TELEPHONE SETS—1500S

CONNECTIONS

1.01 This section is reissued to:

Fig. 2 — 1500S Telephone Set, With 25Y3 Dial and 425G Network, Wired for Speakerphone (Sheet 1 of 2)

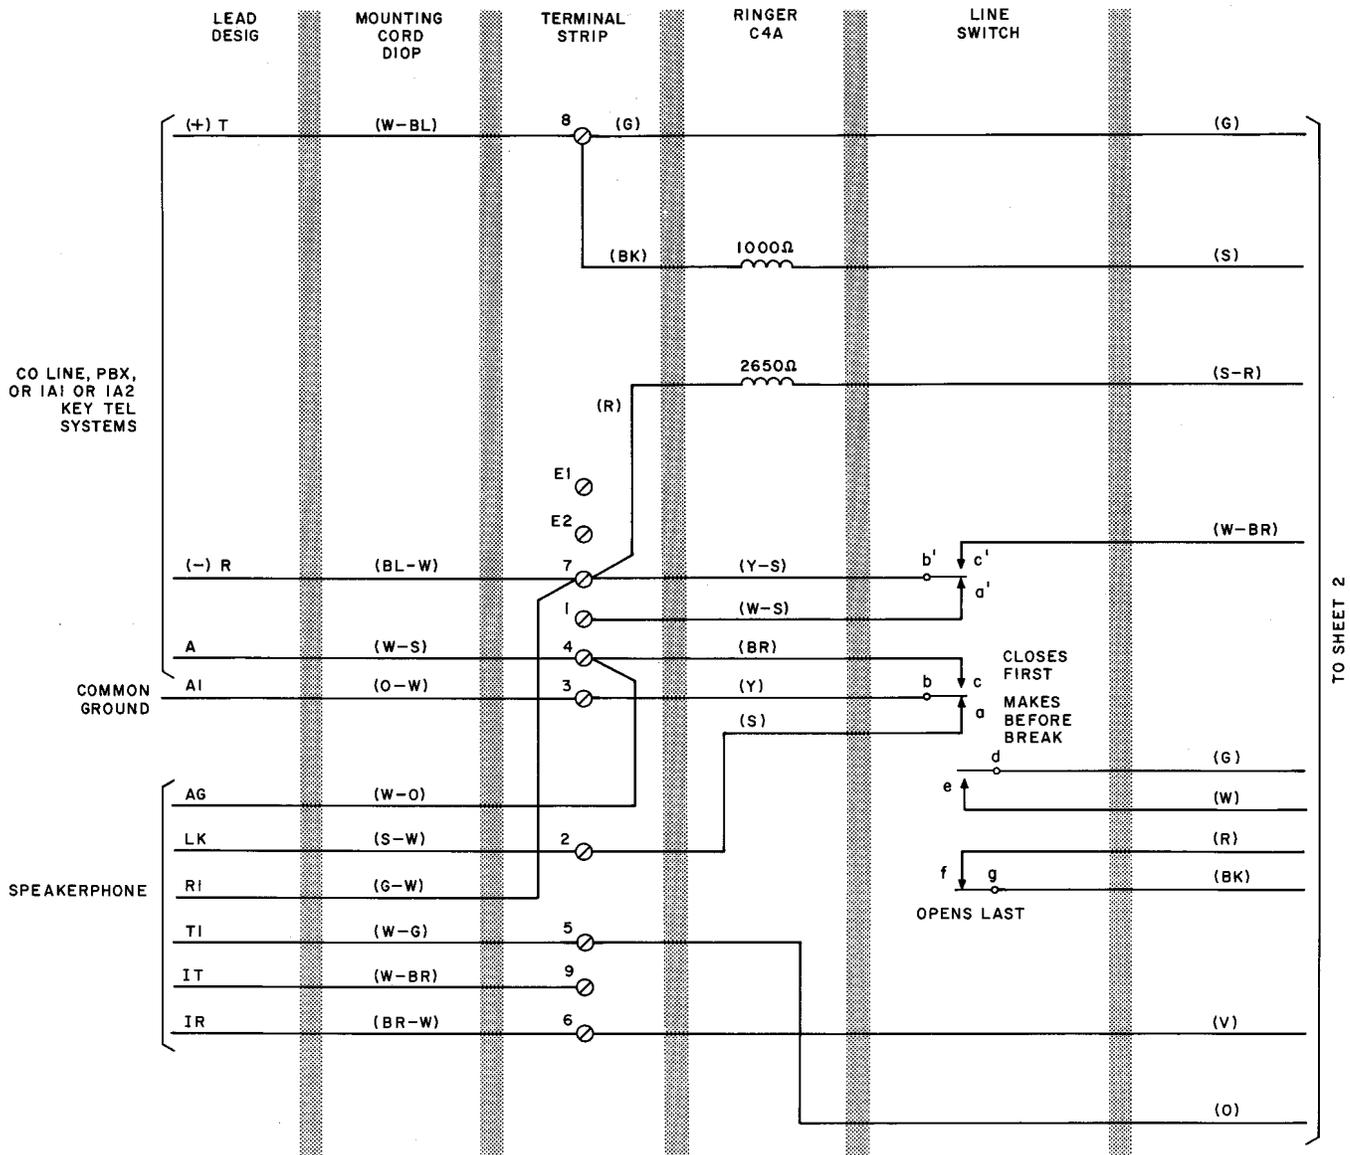
- Add Fig. 2
- Add Table B

TABLE B
MODIFICATIONS FOR ADDING POLARITY GUARD
(FIG. 2)

LEAD		REMOVE FROM	CONNECT TO
Dial	BK	RR	T*
	G-W	C	S*
Polarity Guard	G W		RR C
Line Switch	W-BR	C	S*
